January 7, 2019

**Re: Soil Reuse Plan Response
Former Chemoil Refinery, 2020 Walnut Avenue, Signal Hill, California 90755
LARWQCB Site Cleanup Program No. 1391, Global ID T10000010213**

FIGURE 2-5

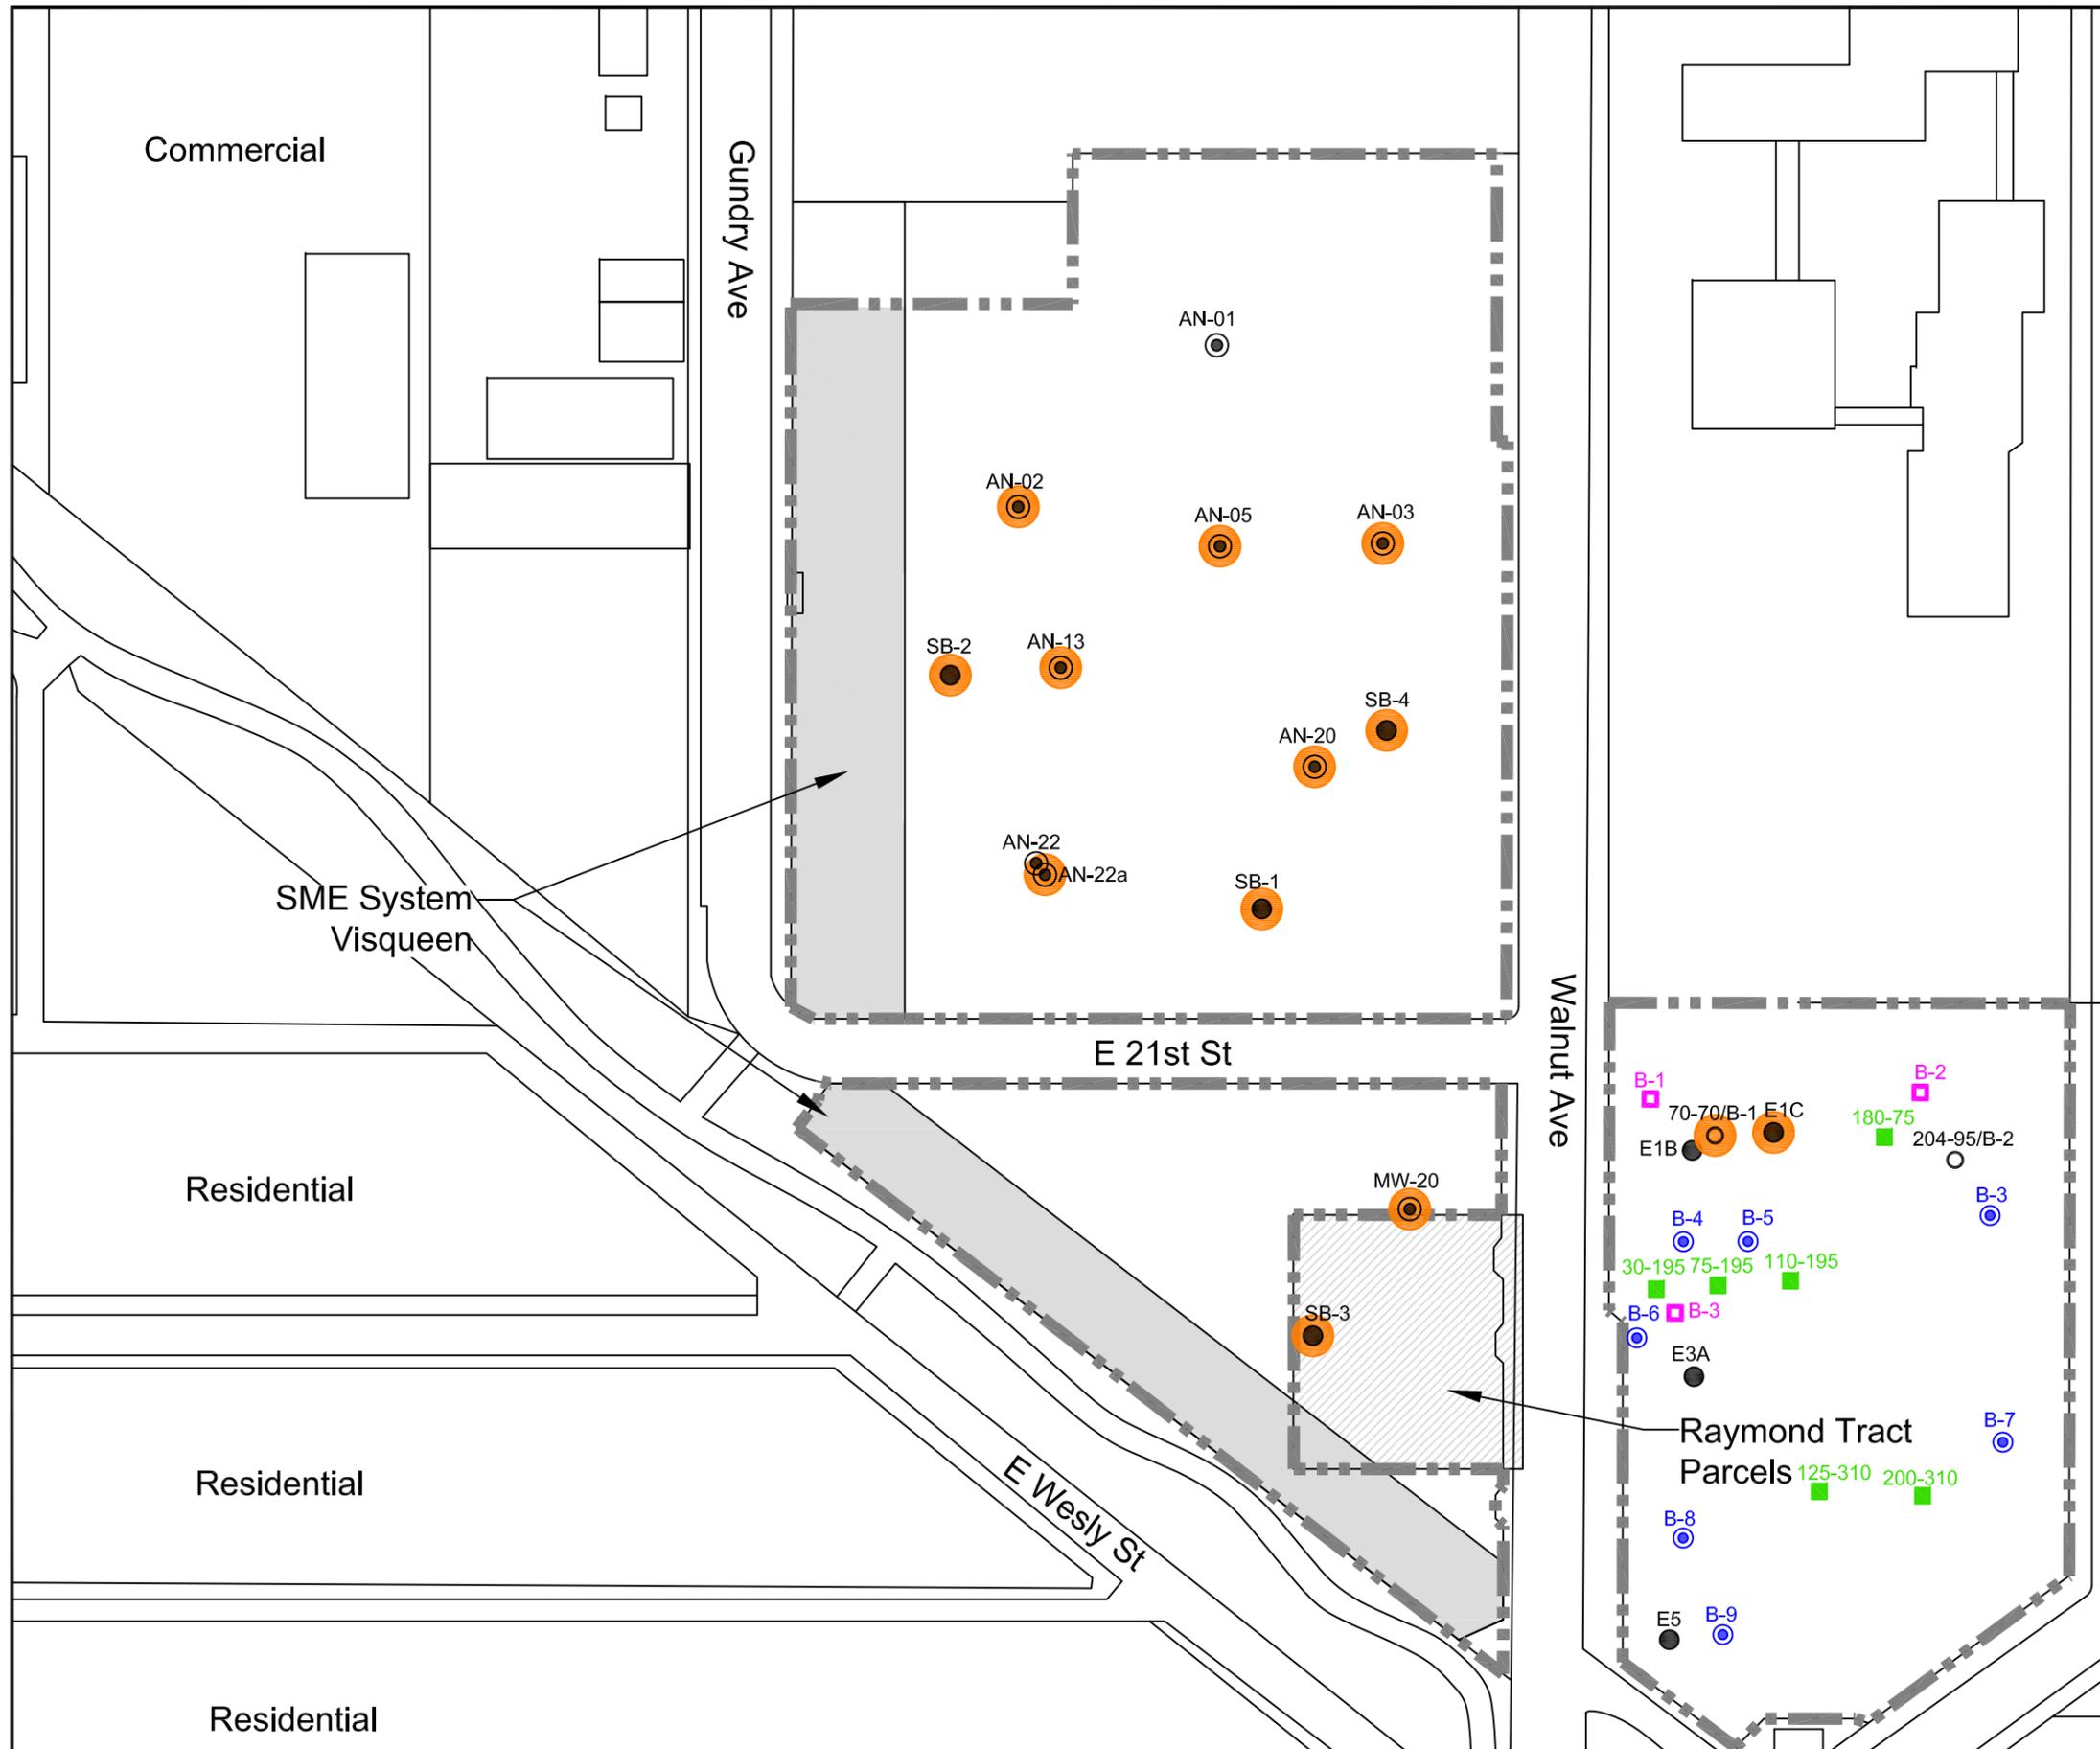
3. Soil may not be reused at the Site if concentrations exceed the final screening levels (SLs), identified in the Response Plan. We are requesting that the Water Board reconsider this requirement. Our soil reuse approach involves treating re-used soil in-situ using the same approach (SVE) had it not been disturbed during redevelopment activities. Refer to Figure 2-5, included in the Response Plan (attached). Based on historical sample collection efforts, the shallow soil throughout much of the western parcel exceeds SLs. Requiring soil that falls above

SLs to be hauled offsite essentially eliminates the ability to reuse soil generated from the Western Parcels. The redevelopment grading plan has been revised to further minimize the disturbance of shallow soil; however, some excavation/replacement of soil will be required for utility installation and removal of subsurface debris. Preliminary estimates indicate that having to dispose of soil offsite from the Western Parcels during site redevelopment will result in approximately \$1,500,000 in soil transportation/disposal/import fill costs and require 1,000 truck trips, which creates a significant CEQA issue. We request that the Water Board consider the following modification to its earlier comment: *Soil may not be reused at the Site if concentrations exceed the final screening levels (SLs), identified in the Response Plan, unless it is being placed in an area with higher concentrations of contaminants that will be treated by SVE. In no circumstance may soil that exceeds SLs be placed on top of soil that is "clean" (i.e., clean being defined as meeting the SLs). In addition, soil that does not meet all of the reuse criteria, identified in item 4 below, may not be reused at the Site.*
